LANL Single-Screen Characterization Well R-34 requires replacement, version 07-22-08 by Robert H. Gilkeson, Registered Geologist

Figure 3. Effect of organic drilling fluids to form a new mineralogy in a zone surrounding the screened intervals that prevents detection and accurate measurement of LANL contaminants in water produced from the LANL characterization wells. The cartoon is an overhead view of the wells.

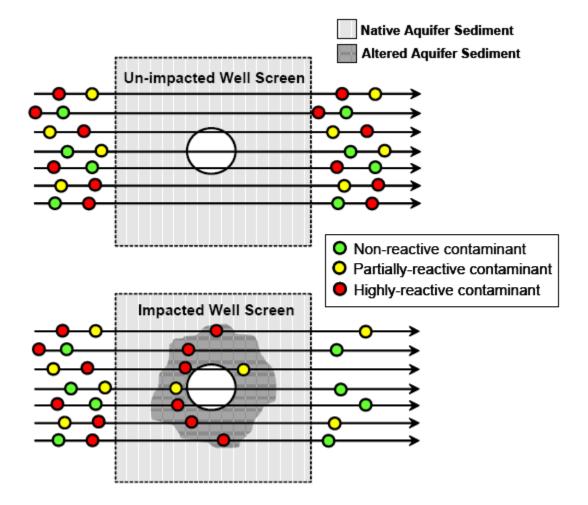
Figure 3 is a cartoon of the new mineralogy that was formed in the sampling zones of practically all of the LANL characterization wells (including wells R-34, R-10 and R-10a) by the organic drilling additives. The new mineralogy in the impacted zone surrounding the well screens are precipitates of iron and manganese that have very strong properties to prevent the detection of many of the LANL contaminants and especially the trace metal radionuclide contaminants that are listed above (i.e., isotopes of plutonium, americium, cesium, etc). These radionuclide contaminants are a special concern for reliable detection and accurate measurement in the regional aquifer at the locations of the LANL characterization well R-13 and LANL wells R-34, R-10 and R-10a on the property of the San Ildefonso Pueblo.

surrounding the screened interval as displayed in Figure 3. The high levels of total iron in the water samples collected over a period of the first two years may indicate high concentrations of suspensions of iron colloids that were formed by the microbial processes.

Source. Figure 2-26 in LANL Hydrogeologic Synthesis Report, LA-14263-MS, December 2005.

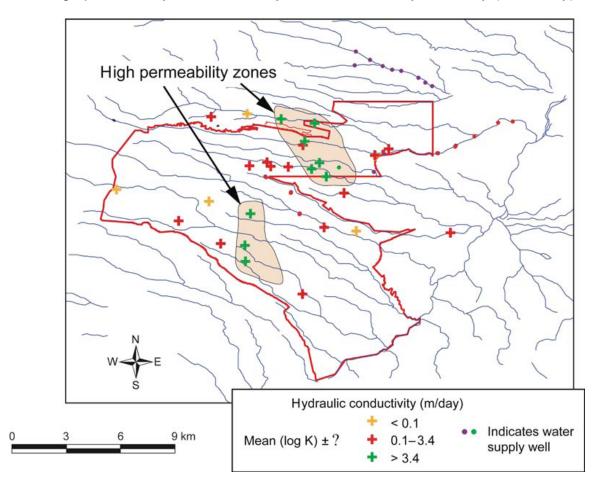
Figure 4 is a map from the Hydrogeologic Synthesis Report that shows two landscape areas in the central part of LANL where the regional aquifer has high permeability. The northern area covers 6.5 square miles and the southern area covers 4 square miles. The two areas are identified as having aquifer strata near the top of the regional aquifer with permeability (i.e., saturated hydraulic conductivity (Ksat)) greater than 3 meters/day (>10 feet/day). On the map, well R-34 is displayed as a red symbol at a location immediately south of the northern area with high permeability.

"As shown in Figure 2-26 [Figure 4 in this exhibit], there appear to be two zones near the top of the aquifer that are particularly conductive (>3 m/day). These zones are not correlated with hydrostratigraphy, suggesting that structure or alteration may be the controlling factor. No high permeability zones occur east of [characterization well] R-13." (p. 2-73)

The conclusion in the LANL *Hydrogeologic Synthesis Report* that there are no high permeability zones (i.e., Ksat > 10 feet/day) east of LANL on the property of the San Ildefonso Pueblo is a serious mistake. The Schlumburger^R geophysics report for well R-34 identified a 72-ft thick section of saturated sediments at the top of the regional aquifer with a permeability much greater than 10 feet/day. Discrete layers within the 72-ft thick section may have Ksats greater than 50 and even greater than 100 ft/day. The description of the highly permeable sediments in the Schlumberger^R report are on page 9 of this exhibit.

The measured permeability values in well R-10 and the geophysics logs for wells R-10 and R-34 are proof that the "high permeability zones" displayed on Figure 4 are also present over a large area on the property of the San Ildefonso Pueblo. Furthermore, the zones with high permeability are along the plume pathway on Figure 2. It is a serious mistake that LANL reports do not recognize the high permeability of the regional aquifer over a large area on the property of the San Ildefonso Pueblo.
